Rezoning Transportation Analysis

Petition Number: 2023-071

General Location Identifier: 03324108, 03324109, 03324110

Date	Description
8-24-23	First Review (TM)

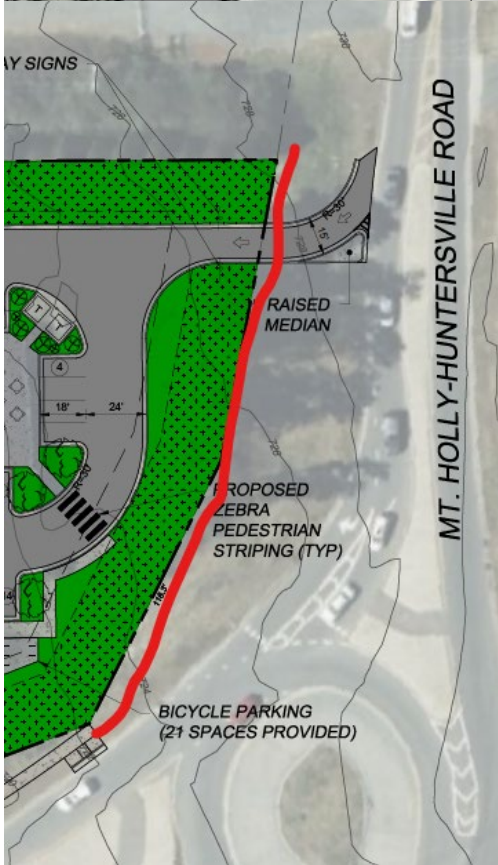
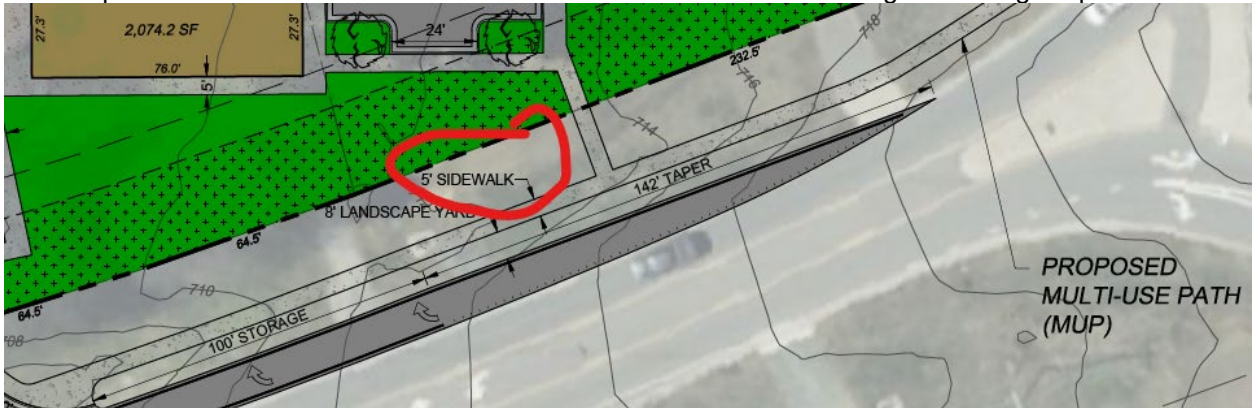
The petition's zoning falls within low intensity development which based on the 1560 daily trips will trigger Tier 3 (9 mitigation points) for multimodal assessment. The petitioner shall review and assess the publicly accessible pedestrian network within ¼ mile walking distance of the site to identify multimodal infrastructure to meet the Tier 3 (9 mitigation points) for multimodal assessment.
